CHANGE ORDER APPROVAL FORM

PROJECT: William Burgess Extension

CHANGE ORDER NUMBER: 004

CHANGE ORDER No. 04 - ESTIMATED COSTS - REV08 Embankment Quantity Added

CROSS SECTIONS		SHEET NO.
WILLIAM BURGESS BLVD. EXTENSION NASSAU COUNTY, FLORIDA		148

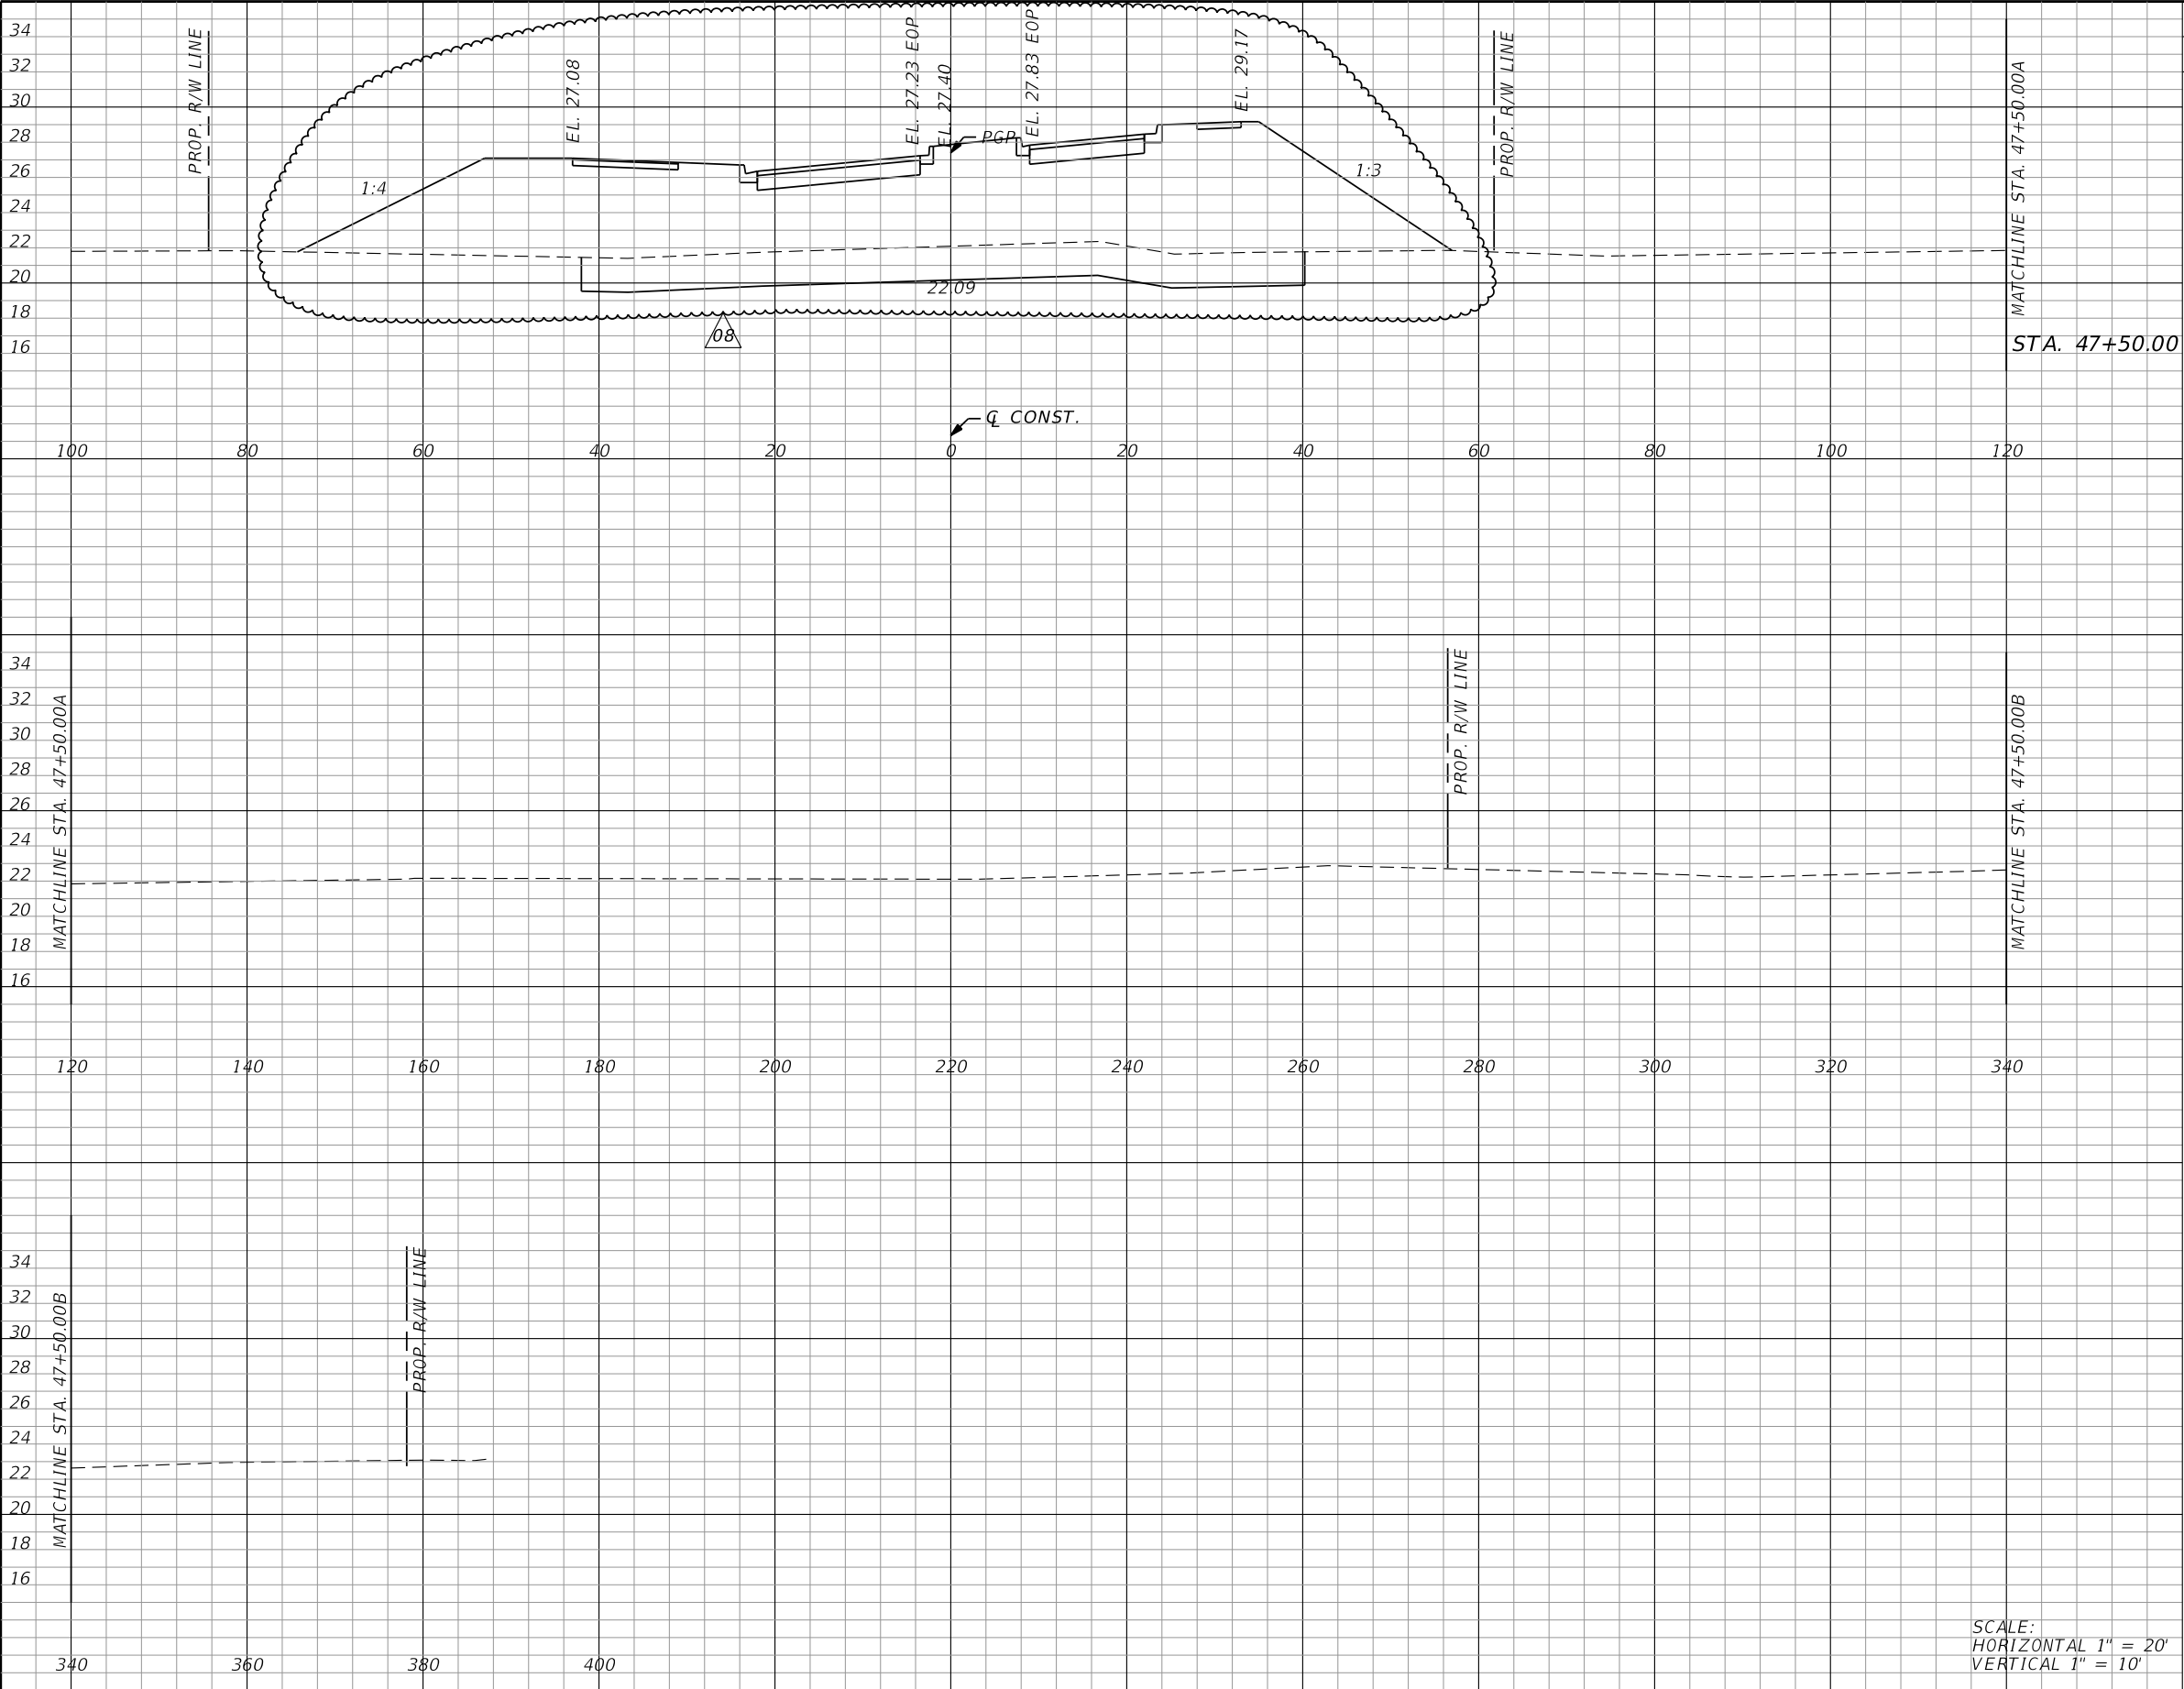
The contractor submitted RFI No. 28, noting a discrepancy in elevations between the drainage structure sheets and the cross-section sheets. As a result, the Engineer of Record issued Plan Revision No. 08, which adjusted the elevations on the cross-sections and added embankment to the original plan quantity.

REVISIONS			
REV	DATE	BY	DESCRIPTION
08	5/6/25	RFH	REVISED PROFILE ELEVATIONS

CROSS SECTIONS		SHEET NO.
WILLIAM BURGESS BLVD. EXTENSION NASSAU COUNTY, FLORIDA		149

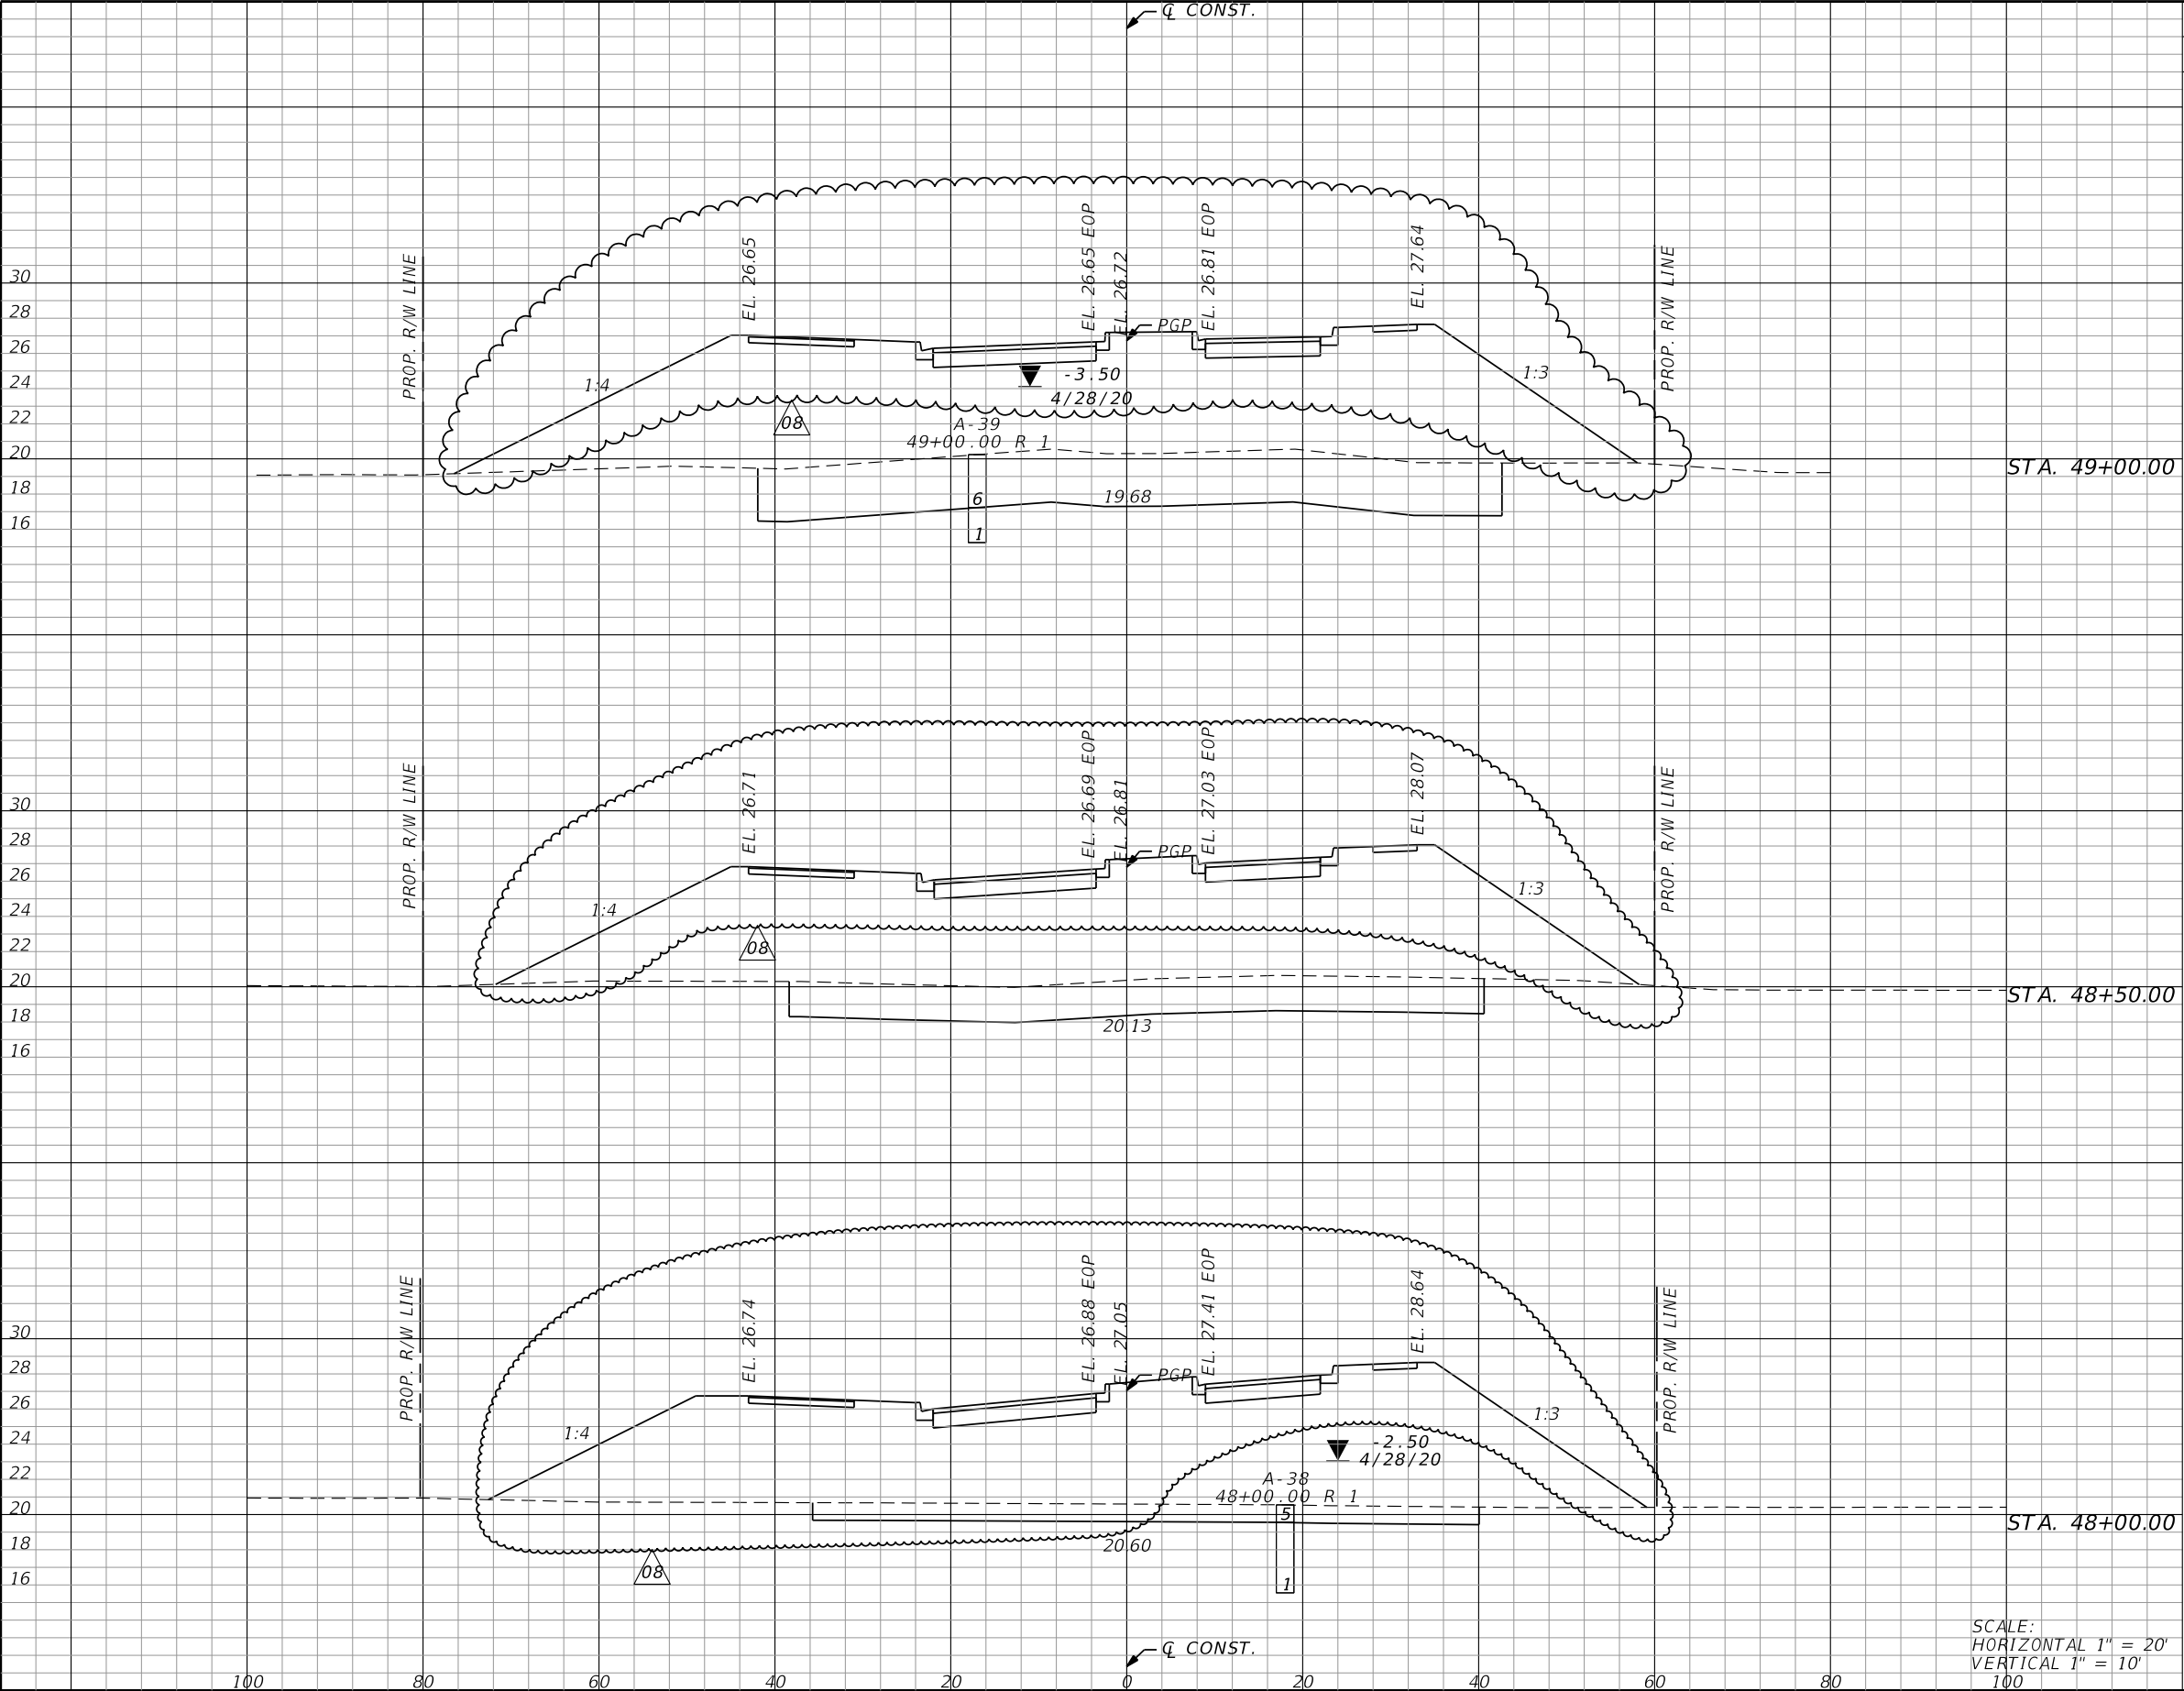
REVISIONS			
REV	DATE	BY	DESCRIPTION
08	5/6/25	RFH	REVISED PROFILE ELEVATIONS

CROSS SECTIONS
WILLIAM BURGESS BLVD. EXTENSION
NASSAU COUNTY, FLORIDA

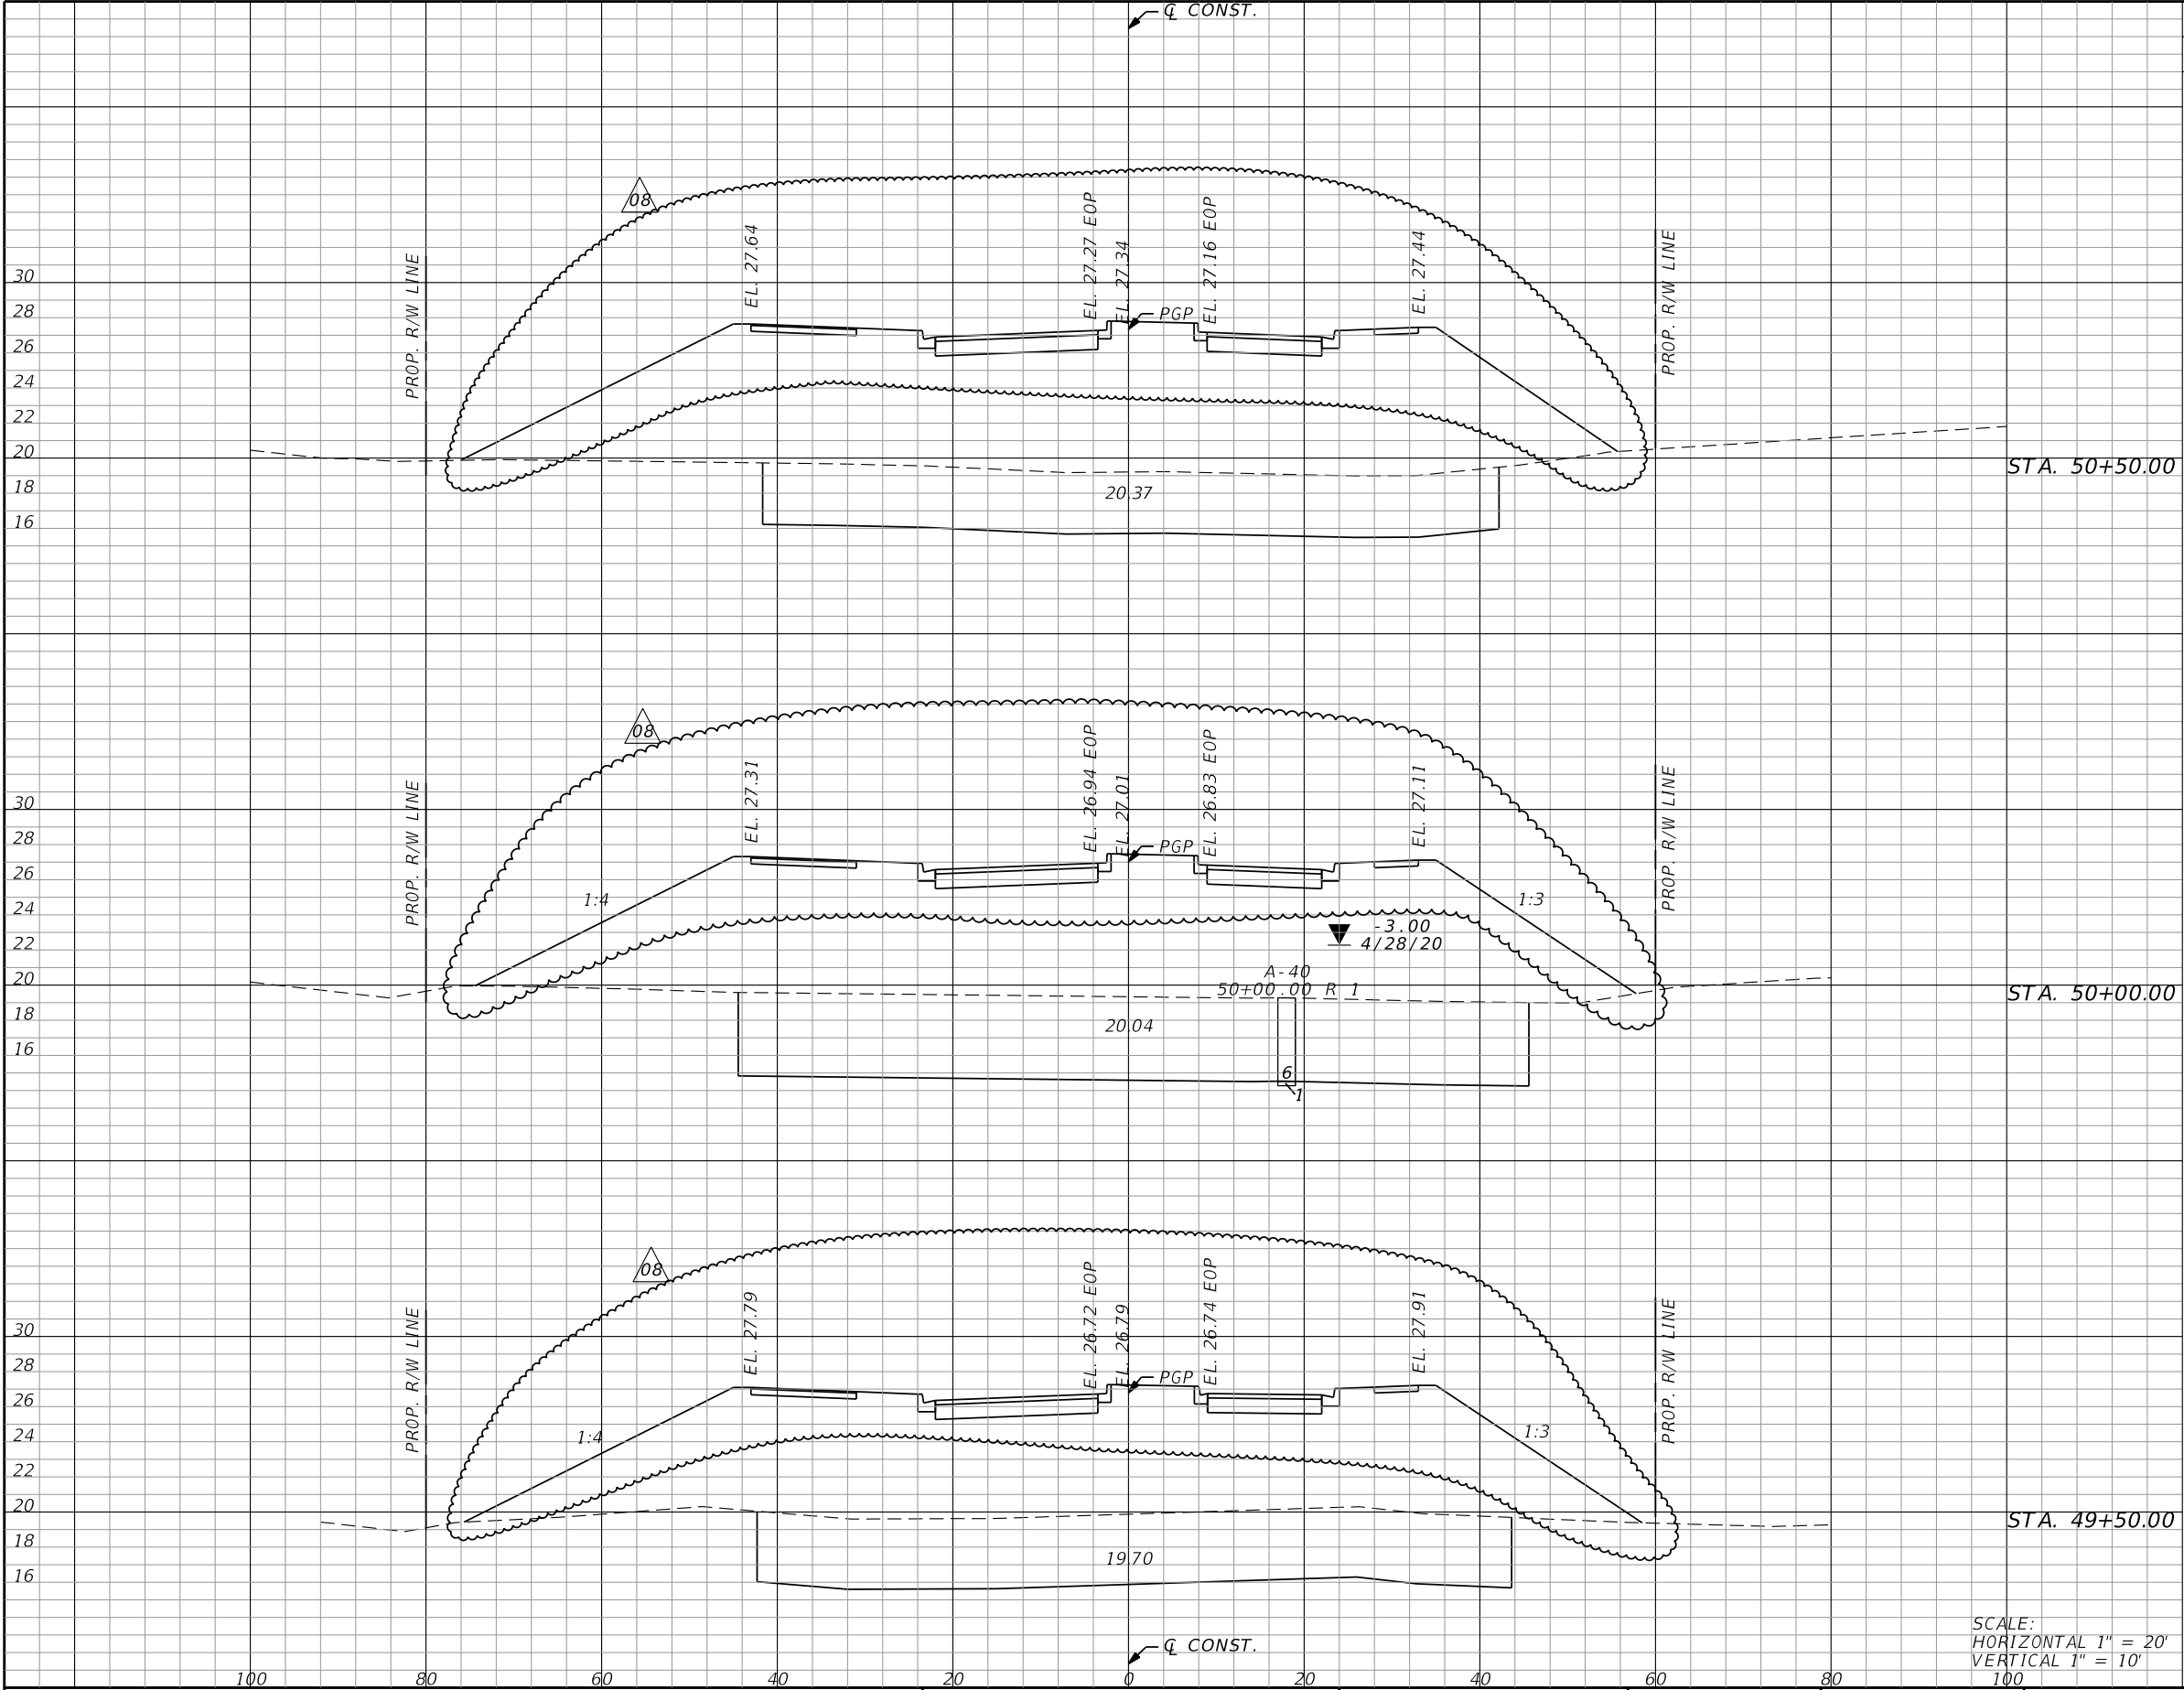
REVISIONS			
REV	DATE	BY	DESCRIPTION
08	5/6/25	RFH	REVISED PROFILE ELEVATIONS
